## LINCOLN CITY/LANCASTER COUNTY PLANNING STAFF REPORT

**P.A.S.:** Rambling Rose Acres, Special Permit # 05054, Community Unit Plan

**PROPOSAL:** A special permit CUP for 9 lots and 3 outlots, including Build Through lots, generally located at Highway 77 and Bennet Road.

This office has reviewed subject development and would offer the following comments:

**GRADING PLAN**

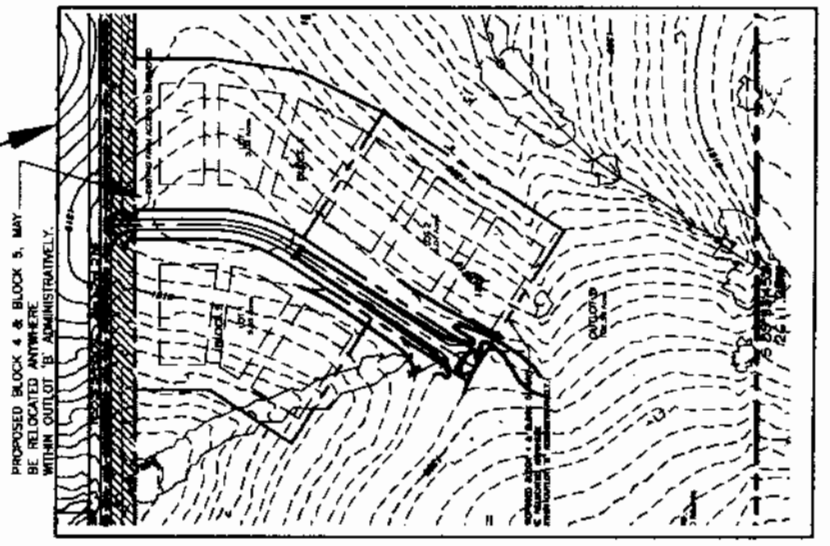
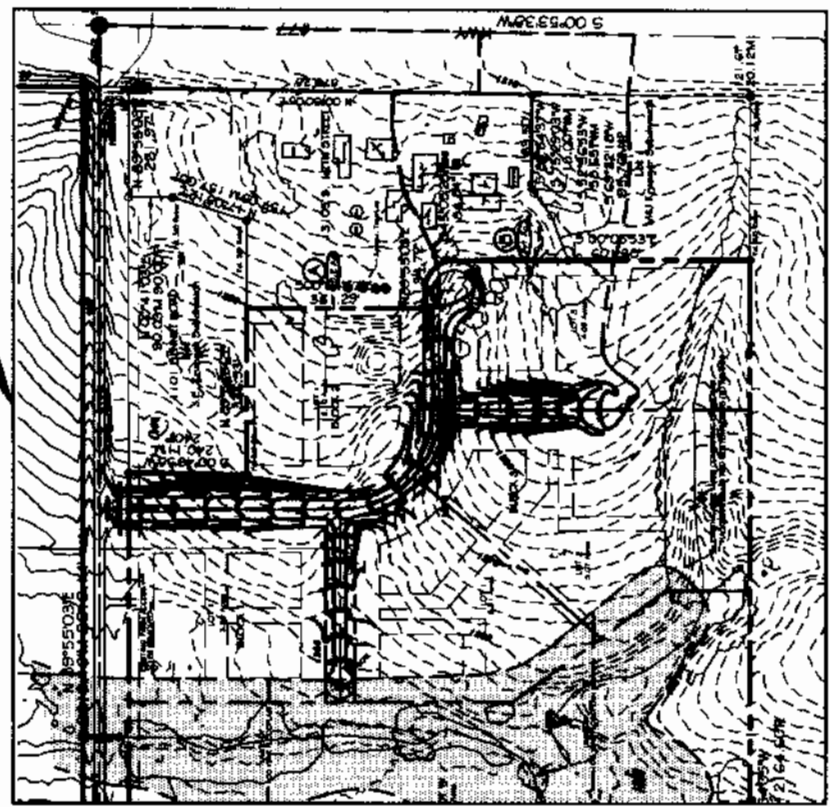
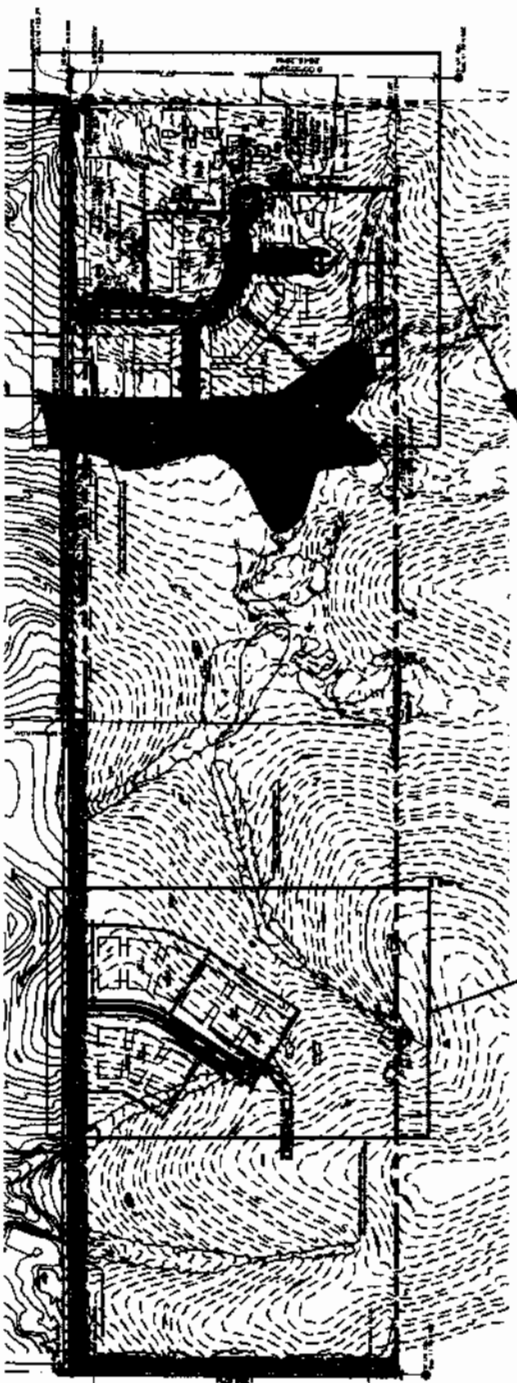
- 5) The typical grading section shall show a minimum width of four (4) feet for the ditch bottom and shall show the ditch backslope at 3:1.
- 6) *General Note No. 12* shall be modified to not allow the existing farm access to remain on Lot 1, Block 1.

- 7) The radius dimension is not shown for the surfacing of the cul-de-sac on South 8<sup>th</sup> Street.
- 8) All culverts shall have a concrete headwall or flared end section on the inlet end.
